Access Compliance Report

Public Rights-of-Way

(Curb Ramps)

Intersection ID: 10019157	Main Street: TIPPAH_PARK_CT	Cross Street: N/A	Location: NE
ADA ID: 81B12C8F9C31	Ramp Type: Perp	Initial Pass/Fail: Fail	Overall Compliance: No
Severity Score: 12.5			
Codes/Mitigation Info/Possible Solution		Field Measurements/Component Compliance

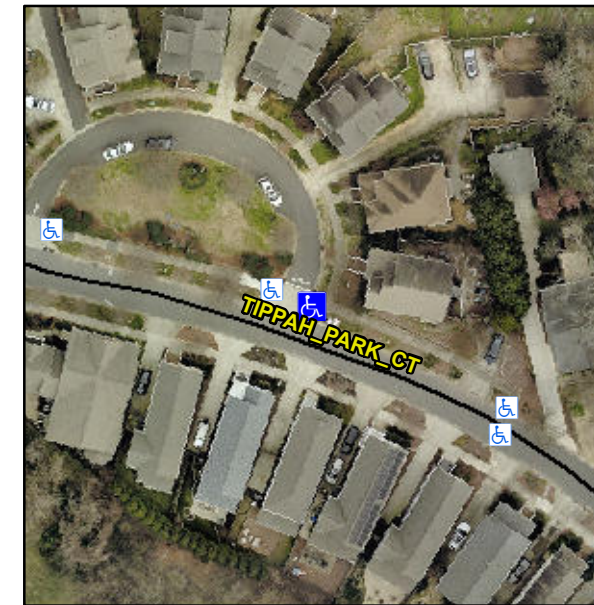
R304.5.3

Compliance	Description	Data	Compliance	Description	Data
N/A	Ramp Length (in)	87.0	Yes	Ramp Slope (%)	6.9
Yes	Ramp Width (in)	61.0	No	Ramp XSlope (%)	6.2
N/A	Flare Type LT	N/A	N/A	Flare Type RT	N/A
N/A	Flare Slope LT (%)	N/A	N/A	Flare Slope RT (%)	N/A
N/A	Flare Traversable LT?	N/A	N/A	Flare Traversable RT?	N/A
N/A	Landing Length (in)	N/A	N/A	DWS Provided?	N/A
N/A	Landing Width (in)	N/A	N/A	DWS Contrast?	N/A
N/A	Landing Slope (%)	N/A	N/A	DWS Length (in)	N/A
N/A	Landing X Slope (%)	N/A	N/A	DWS Full Width?	N/A
N/A	Landing Curb? (Y/N)	N/A	N/A	DWS Offset (in)	N/A
N/A	Shared Landing?	N/A			
N/A	Gutter Ponding?	N/A	N/A	Gutter Slope (%)	N/A
N/A	Gutter Lip Ht (in)	N/A	N/A	Gutter X Slope (%)	N/A
N/A	Painted X Walk1?	No	N/A	Painted X Walk2?	N/A
	X Walk 1 Direction	To NW		X Walk 2 Direction	N/A
N/A	X Walk 1 Width (in)	N/A	N/A	X Walk 2 Width (in)	N/A
	X Walk 1 Slope (%)	1.6		X Walk 2 Slope (%)	N/A
	X Walk 1 X Slope (%)	6.8		X Walk 2 X Slope (%)	N/A

Remove & Replace Entire Ramp.
